Docket Item# 1  
BAR CASE #2012-0043

BAR Meeting  
March 21, 2012

**ISSUE:** Certificate of Appropriateness for Alterations/Signage

**LOCATION:** 702-704 King Street

Figure 13: Fascia/Cornice Detail

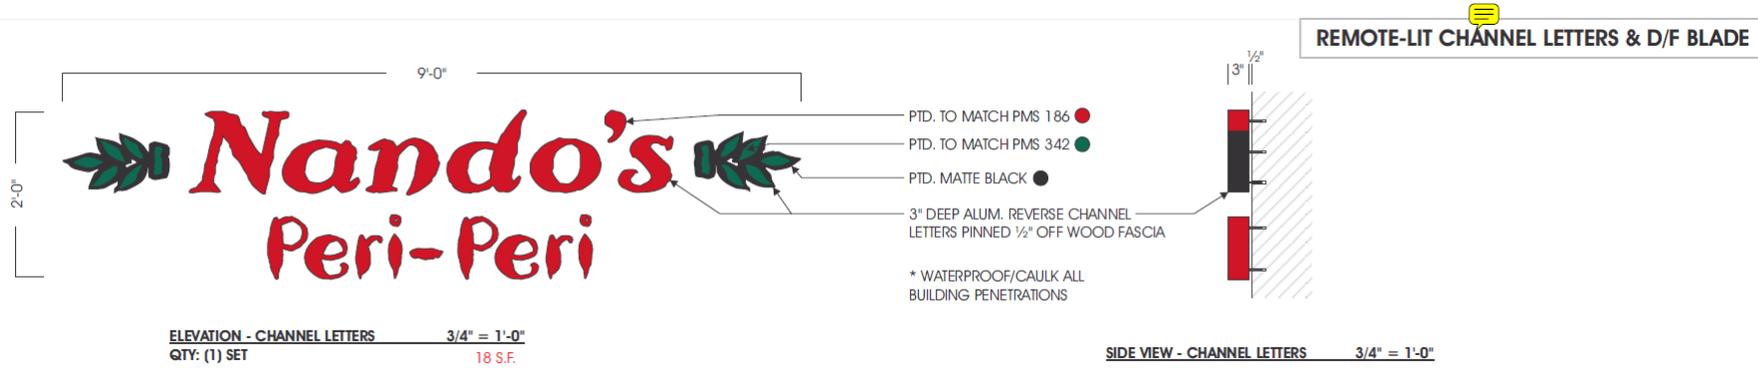
Finally, Staff suggests that the panel detailing on the bulkhead below the window could be fabricated out of milled, wood solid composite material, as it has been observed that wood bulkheads deteriorate quickly due to their exposure to water splash during rain events.

**STAFF RECOMMENDATION:** Staff recommends approval of the Certificate of Appropriateness with the recommendation that the applicant may utilize a millable, paintable, wood composite material for the construction of the storefront bulkhead.

**Figure 15: Proposed Hanging Sign and Lighting Specifications**

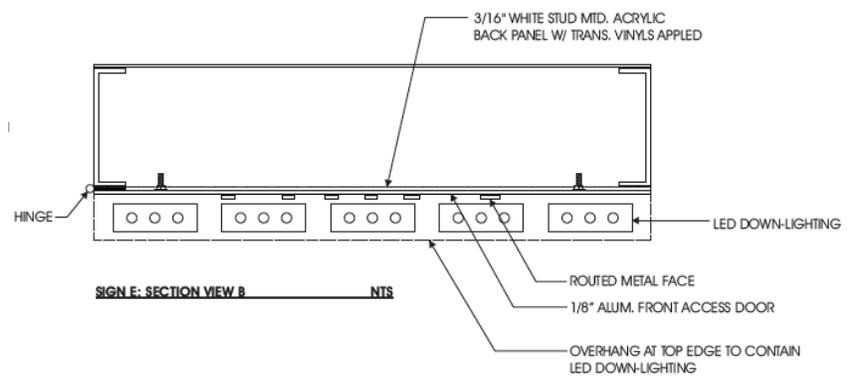
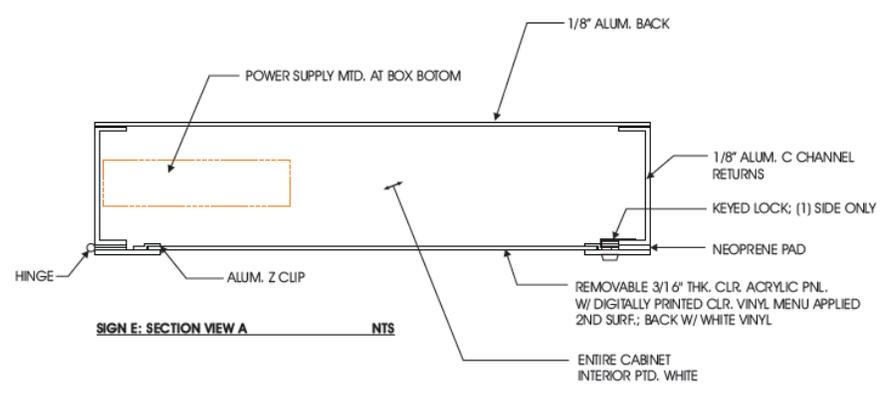
- C-1 Proposed hanging sign (6.2 sq ft) and wall sign (18 sq ft) comply with zoning based on a frontage of 28 feet. The hanging sign is located approximately 12' above the sidewalk.
- C-2 SUP 2011-0089 to allow the restaurant use must be approved prior to BAR hearing. All alterations/ signs must comply with the approved special use permit.
- C-3 The applicant must indicate the location of the front property line. Front façade improvements cannot encroach into the public right-of-way.
- C-3 All alterations must comply with the Storefront Guidelines of the King Street retail strategy per section 6-7-5(F)(2).
